FINAL PRODUCT/PROCESS CHANGE NOTIFICATION #16663Generic Copy

Issue Date: 26-Jun-2012**TITLE:** Conversion to Matte Tin due to SnPb Plating Line EOL in Amkor Korea K1**PROPOSED FIRST SHIP DATE:** 26-Sep-2012 or earlier upon customer approval**AFFECTED CHANGE CATEGORY(S):** Assembly - Plating Material**FOR ANY QUESTIONS CONCERNING THIS NOTIFICATION:**Contact your local ON Semiconductor Sales Office or Sarah Sanico<ffxxh@onsemi.com>**SAMPLES:** Contact your local ON Semiconductor Sales Office**ADDITIONAL RELIABILITY DATA:** AvailableContact your local ON Semiconductor Sales Office or Phine Guevarra<phine.guevarra@onsemi.com>**NOTIFICATION TYPE:**

Figure 1. Acoustic Microscopy Image prior Moisture Resistance test.

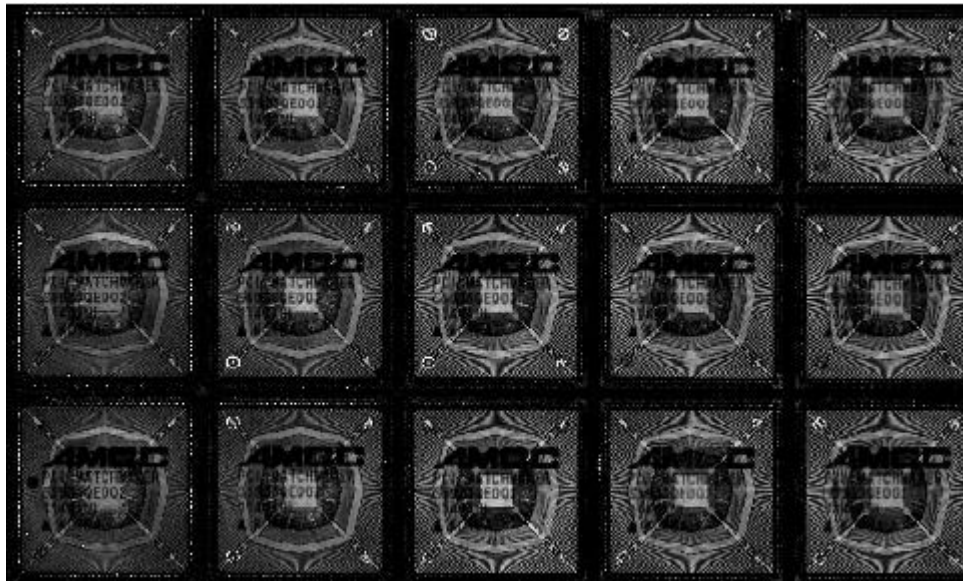
Test	Test Conditions	Result
Moisture Preconditioning (PC)	Moisture Soak (MSL = 3) Solder Reflow (3x @ 260°C)	0/462 (Figure 1&2)
Delamination check (SAT)	Acoustic Microscopy	0/231
HAST Unbiased (UHST)	130°C/ 85%RH for 96 hrs	0/231 (Figure 4)
Preconditioning Temperature Cycling (TC)	-55°C to 125°C for 100 cycles	0/231 (Figure 3)
Temperature Cycling (TC)	-65°C to 150°C for 500 cycles	0/231 (Figure 5)
Wire Bond Pull Strength (WBP)	Cond. C or D. Minimum pull strength after temperature cycle = 3 grams	0/5 (Figure 8)
High Temperature Storage (HTS)	150°C for 1000 hrs	0/77
X-ray	Not Applicable	0/45 (Figure 6)
Internal Visual	Not Applicable	0/10 (Figure 7)
External Visual	Not Applicable	0/ All sample size (Figure 10)
Wire Bond Shear (WBS)	Not Applicable	0/5 (Figure 9)
Solderability (SD)	Not Applicable	0/15
Physical Dimensions (PD)	Not Applicable	0/30
